UNITED STATES
DEPARTMENT OF THE INTERIOR
BUREAU OF LAND MANAGEMENTNMOCD
ArtesiaFORM APPROVED
OMB NO. 1004-0137
Expires: January 31, 2018**SUNDRY NOTICES AND REPORTS ON WELLS**
*Do not use this form for proposals to drill or to re-enter an abandoned well. Use form 3160-3 (APD) for such proposals.*5. Lease Serial No.
NMNM3606

Fasken Oil and Ranch, Ltd. proposes to recompleate the Lake shore SC 10 Fed. Com. No. 4 from the Strawn to the Wolfcamp. Please see attached procedure and current/proposed wellbore diagrams.

Lake Shore Fed S C 10 4
30-015-31569
Fasken Oil & Ranch Limited
March 08, 2017
Conditions of Approval

Proposed 2-22-17

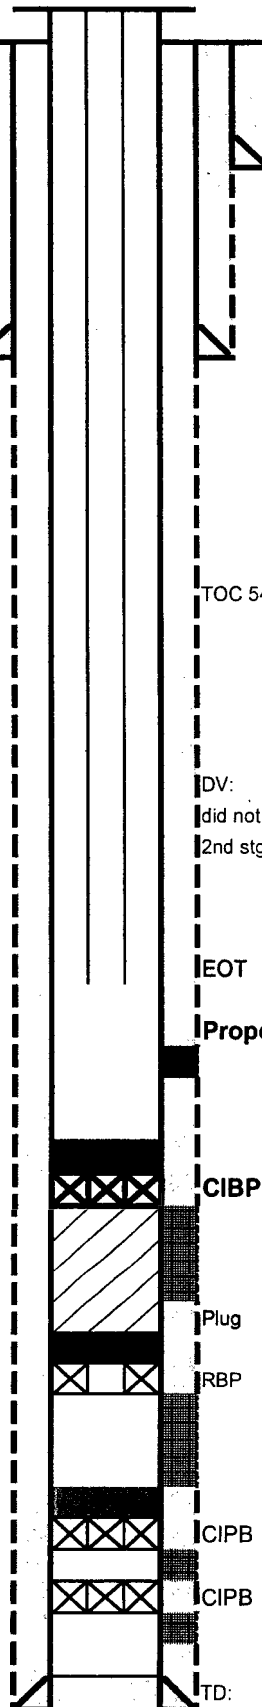
- 1. Operator shall tag RBP at 10,492' and place Class H Cement on top tagging at 10,157' as proposed to seal the Morrow formation.**
- 2. Operator shall place CIBP at 9610' and place 25x Class H cement as proposed. WOC and tag.**

- 3. Must conduct a casing integrity test before perforating and fracturing. Submit results to BLM. The CIT is to be performed on the production casing to max treating pressure. Notify BLM if test fails**
